614 13th Avenue East

Recommendation Packet | SDCI Project #3021532
February 15, 2017

Street View from SW

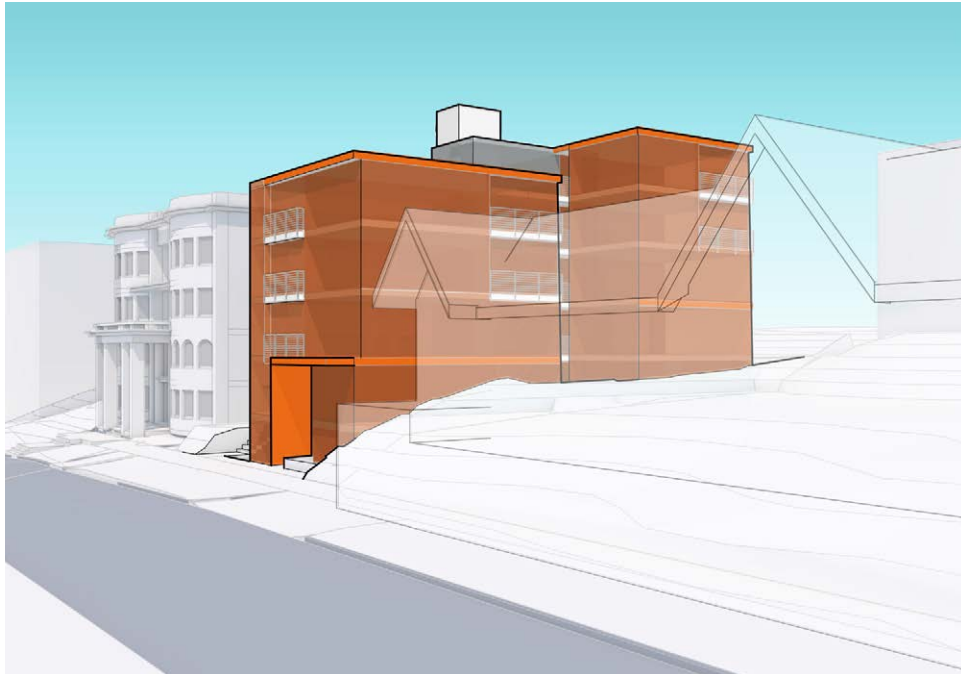
b. The Board discussed the overlap of the northeast corner and the Maryland Apartment projection. Recognizing that an additional setback in this area would likely shift the massing toward the rear and encroach upon the rear setback, the Board supported the proposed massing as shown. (Guidelines CS1.B, CS2.D.5)

Summary Response
The massing strategy has been maintained with one minor change. The elevator and stair have switched places in plan, shifting the taller elevator volume further east to reduce solar impacts on the Maryland apartment to the north. (Guideline CS1.B, CS2.D.5)

The proposed building engages the existing context, proposing a design that is current and relevant while carefully knitting old with new. The structure is sited to provide a large setback to the adjacent Maryland Apartment to the north, minimizing the shadow impacts and preserve the views to the historic Maryland front facade from the south. (Guidelines CS.3.A.1, CS3.A.2)

Aerial View from NW

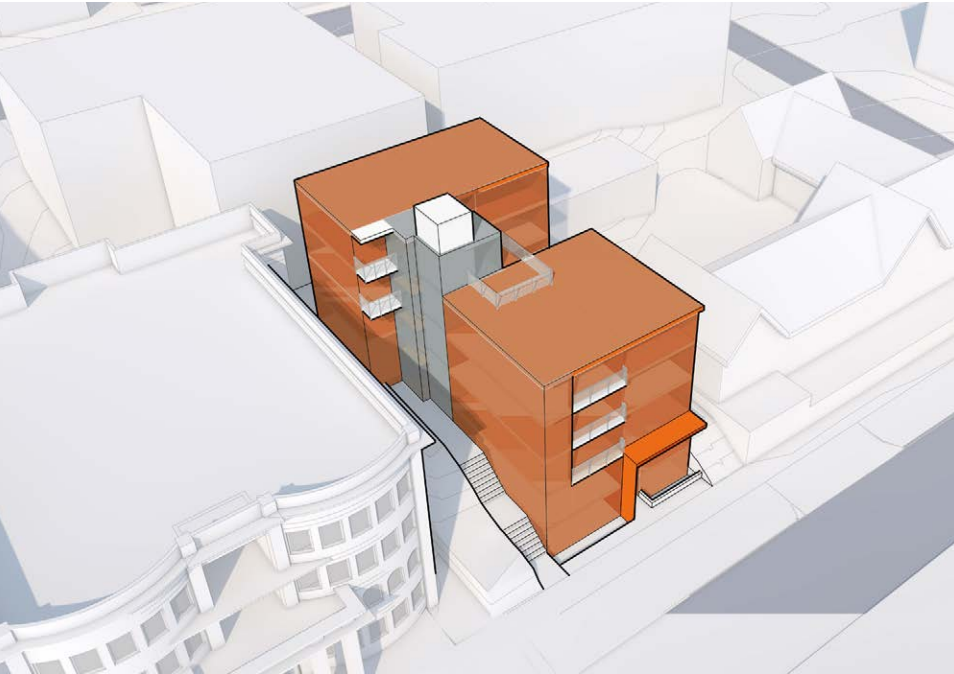
In addition the circulation element material cladding has been adjusted to be more differentiated from the rest of the massing. In the rendered elevations, the circulation element now reads as distinct in both panel color and material detailing. It is now shown as white 2x8 panels, distinct from the adjacent gray 4x8 panel cladding to the east and the brick cladding to the west.

The circulation element material cladding has been adjusted to be more differentiated from the rest of the massing. In the rendered elevations, the circulation element now reads as distinct in both panel color and material detailing. It is now shown as white 2x8 panels, distinct from the adjacent gray 4x8 panel cladding to the east and the brick cladding to the west.

Courtyard View

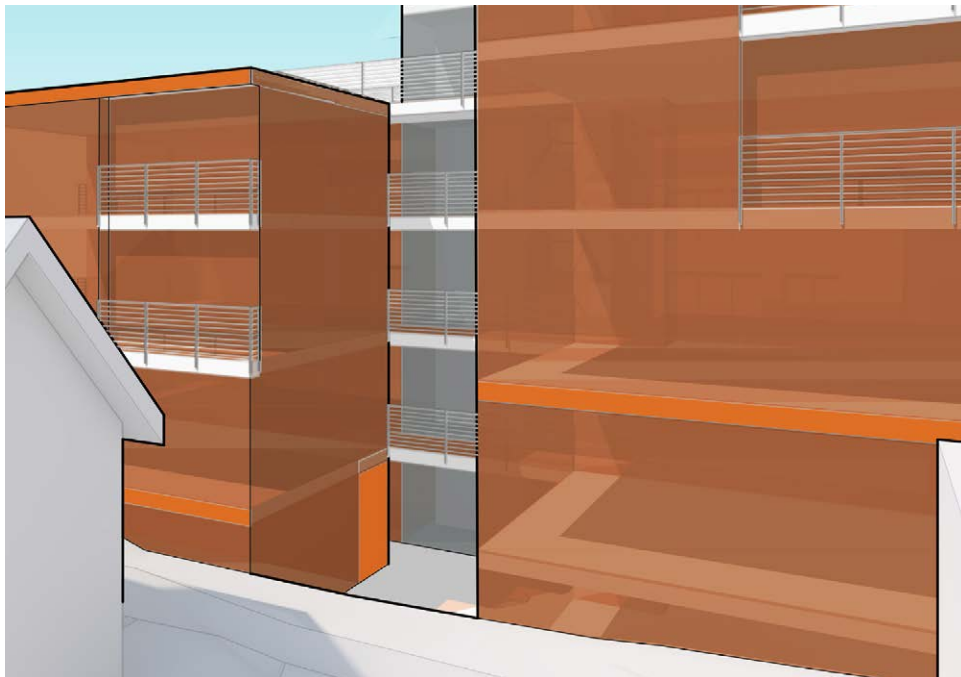
a. The courtyard amenity space location is desirable, as it breaks up the massing along the south frontage and appears to align with the drive for the adjacent development to the south. (Guidelines CS1.B, CS2.D.5)

The courtyard is used to separate the proposed massing into two distinct volumes, knitted together by the courtyard and the adjacent vertical circulation mass in between. The courtyard is aligned with the adjacent drive for the development to the south in order to receive the maximum amount of natural daylight from the south. (Guideline CS1.B, CS2.D.5)

North setback with plan of proposed trash area, planters, and egress path

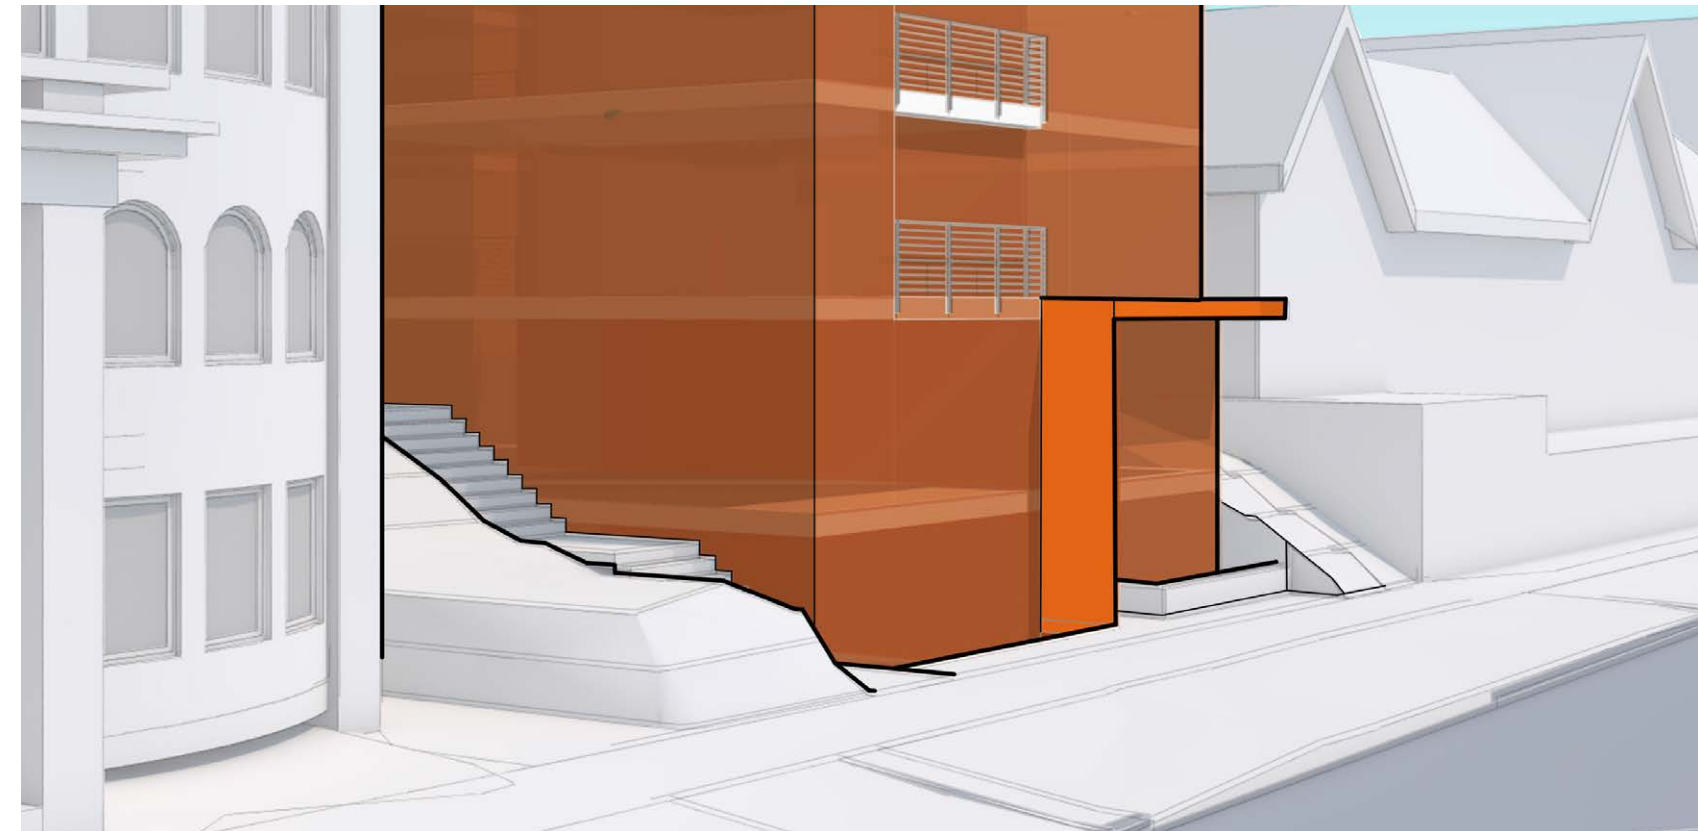
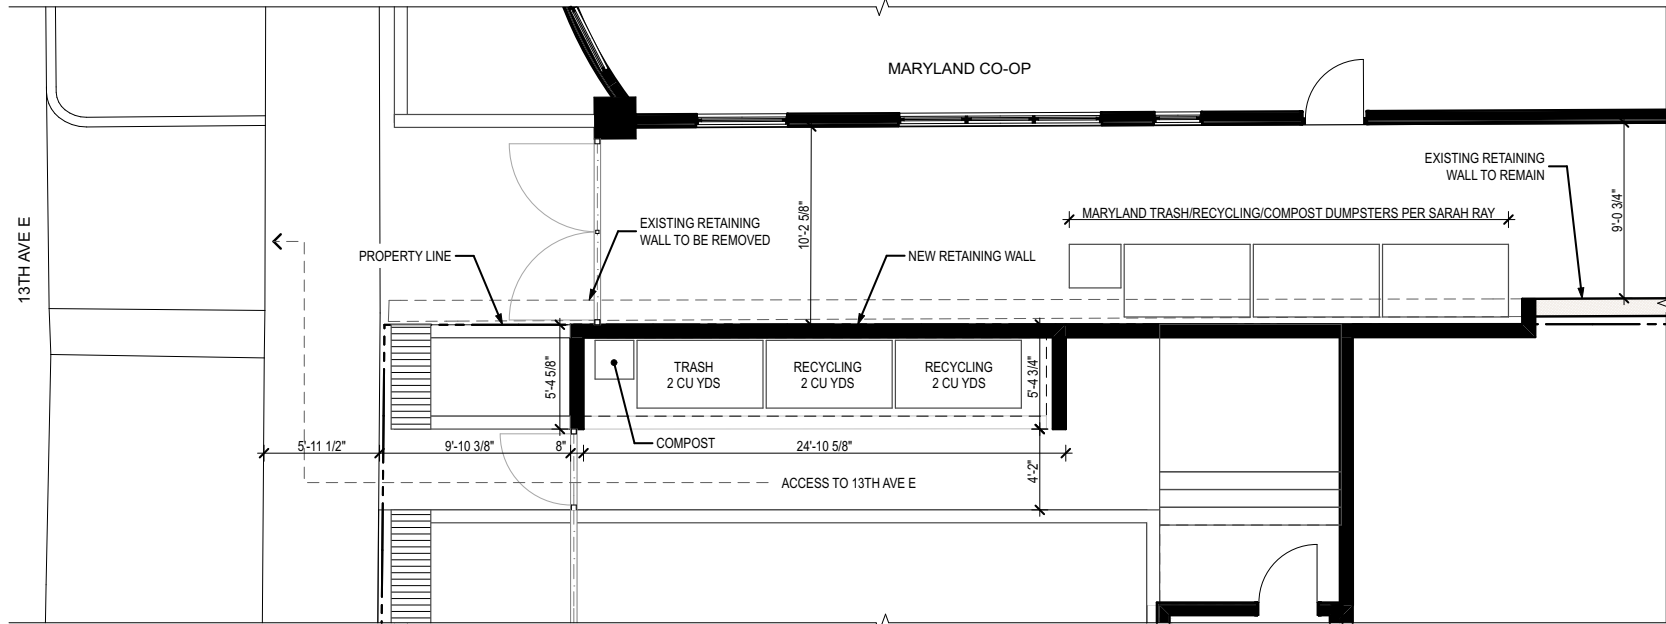
Summary Response
Through outreach with the adjacent residents, the applicant has redesigned the area between the proposed structure and the Maryland Apartment, removing the mature vegetation. This results in a more open and secure area between the structures and provides greater access to light and air for the current and future residents of the Maryland Apartment. New landscaping is proposed. (Guideline CS1.D.1, CS2.D.2)

e. The Board agreed with the public comments regarding the location and treatment of the trash area and directed the applicant to resolve the proposed location of trash and recommended screening trash areas from the street to provide a pleasant pedestrian experience. (Guideline DC1.II)

Summary Response
Through outreach with the adjacent Maryland Apartment, the applicant has redesigned the trash area, now located between the proposed structure and the Maryland Apartment. It is proposed to be screened and covered and is lined with a planters, benches and landscaping to create a pleasant pedestrian experience. (Guideline DC1.II)

In response to the Board's guidance the "front porch" is extended across the full frontage of the parcel, creating a continuous frontage in deference to the Maryland structure. Planters and bench seating engage the sidewalk and adjacent structure, contributing to the visual connection to the Maryland when viewed from the south. Landscape continues across the planting strip in response to the Board's guidance.

The proposed egress and trash storage area shown here was an iterative process that results in an improved street presence and increases light and airflow to the neighboring Maryland Apartments.

**NORTH PRIVACY ELEVATION
(MARYLAND APARTMENTS)**

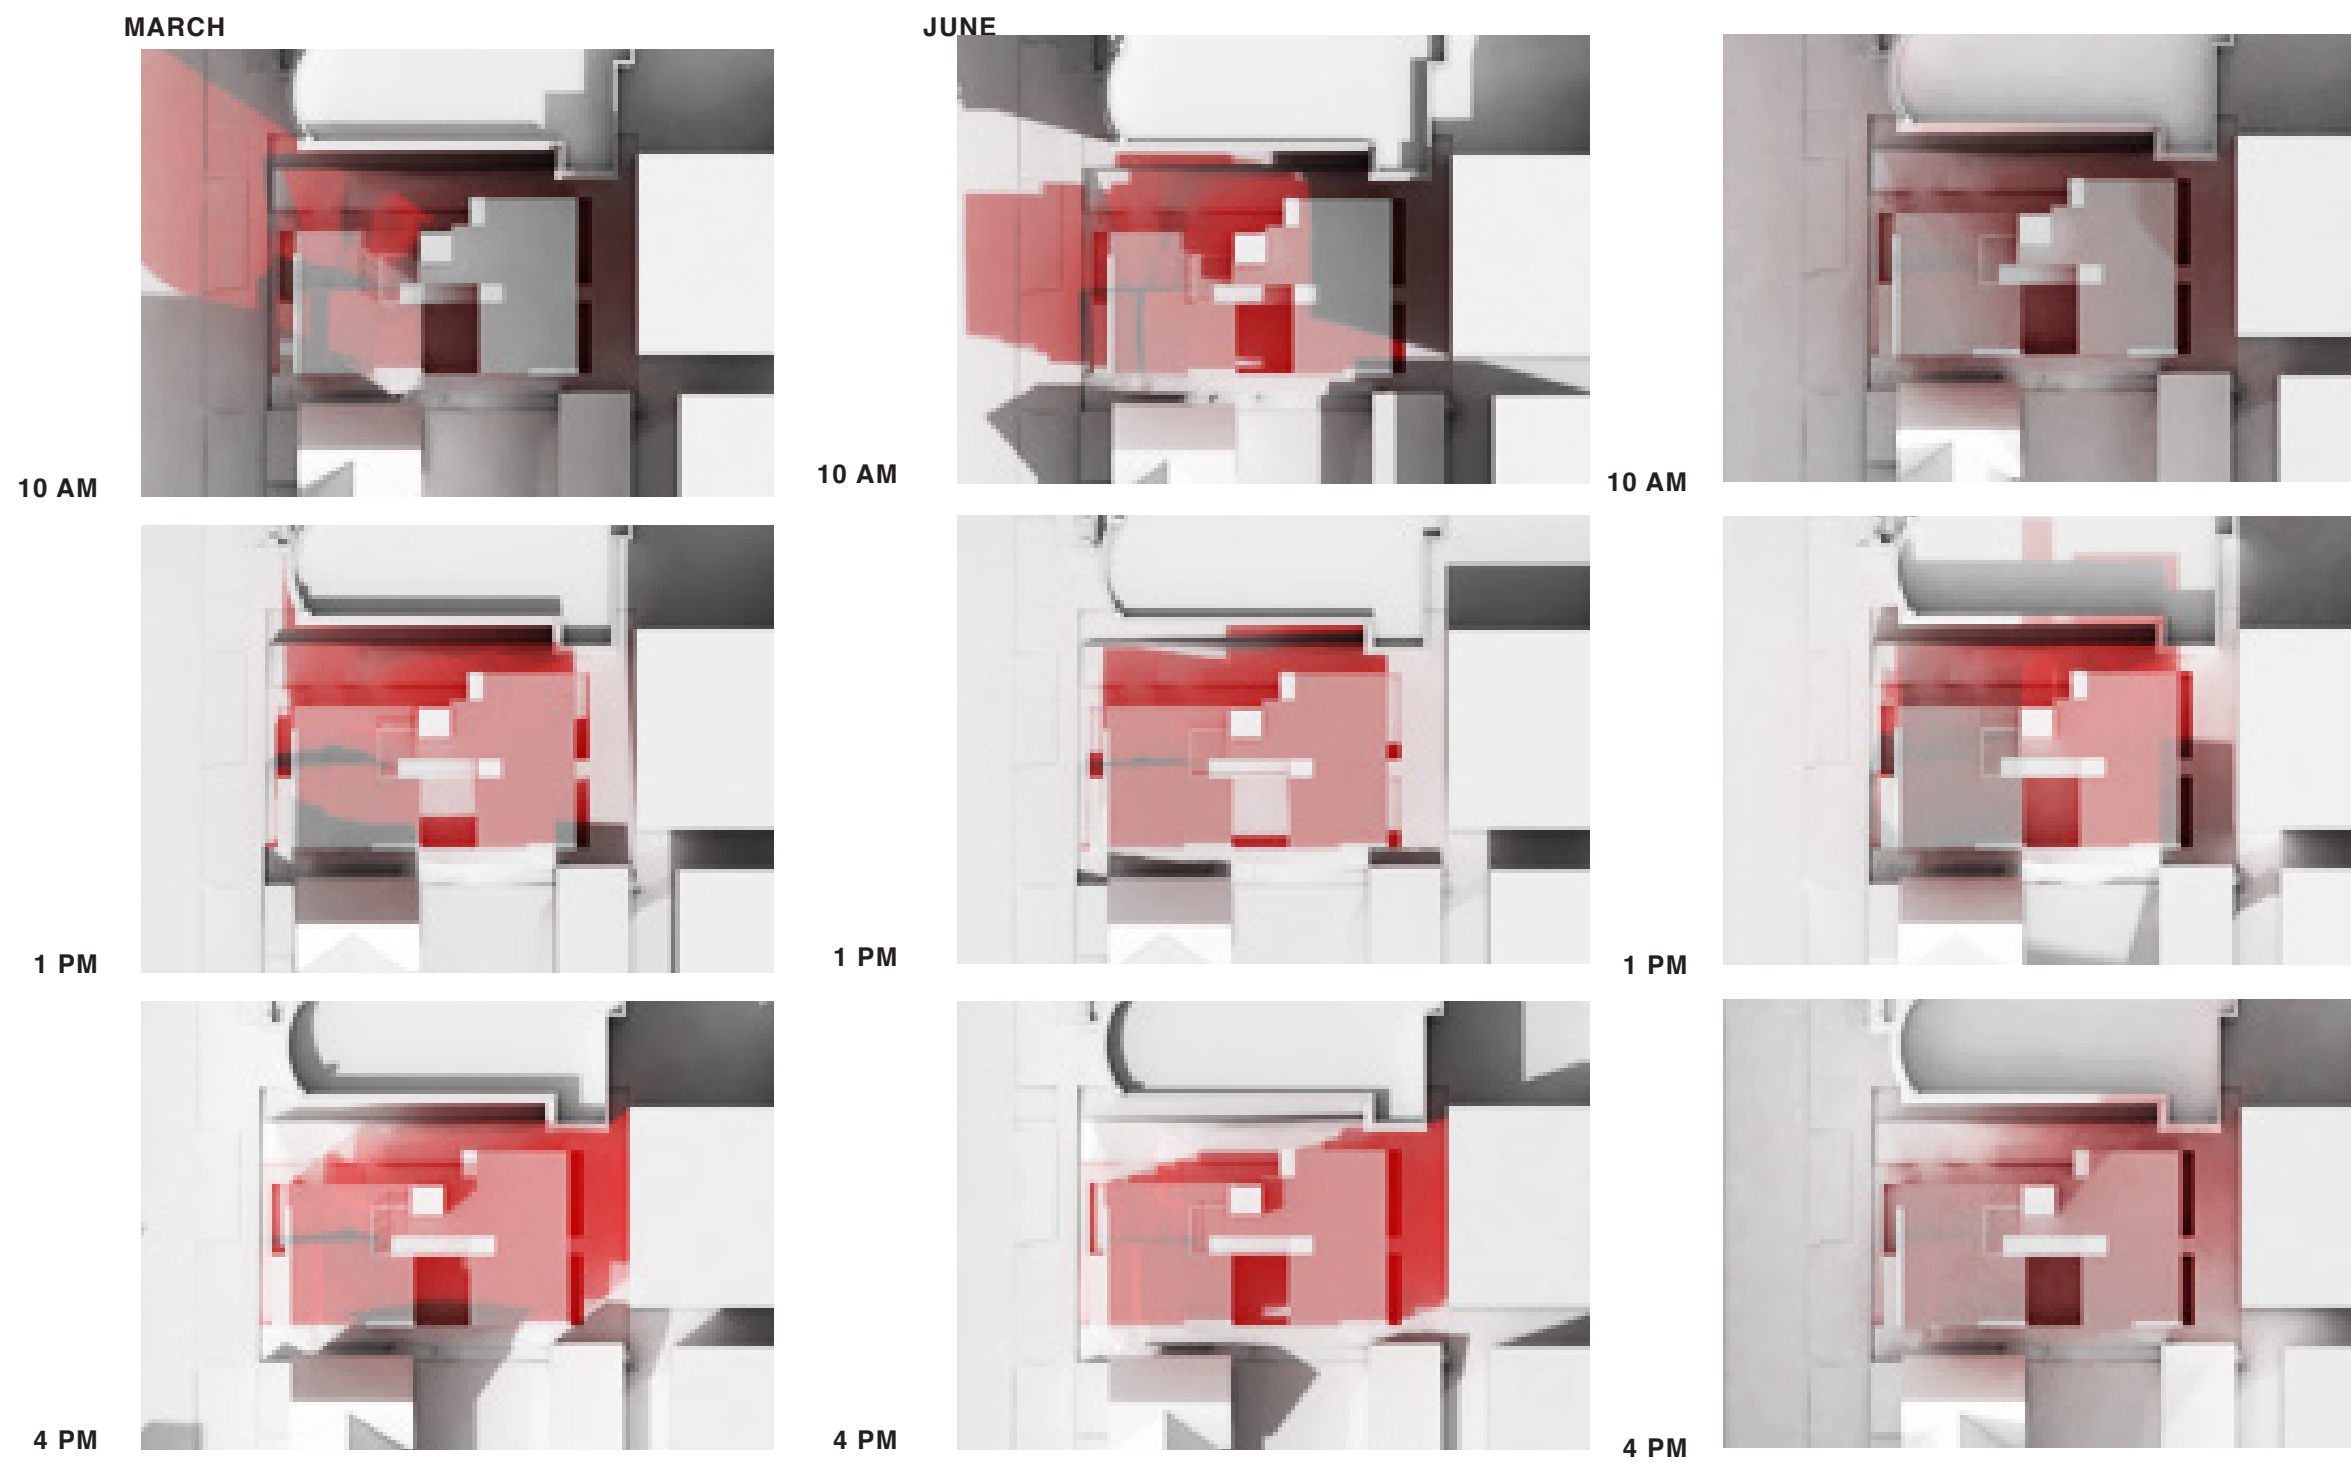
d. Similar to the public's concerns regarding privacy, the Board directed the applicant to provide window mapping studies for all adjacent facades to protect the privacy of neighboring properties. (Guideline CS2-D-5)

Summary Response
Window mapping studies (privacy elevations) have been provided for all adjacent facades. There are no overlaps that impact privacy for any of the neighboring properties. (Guideline CS2-D-5)
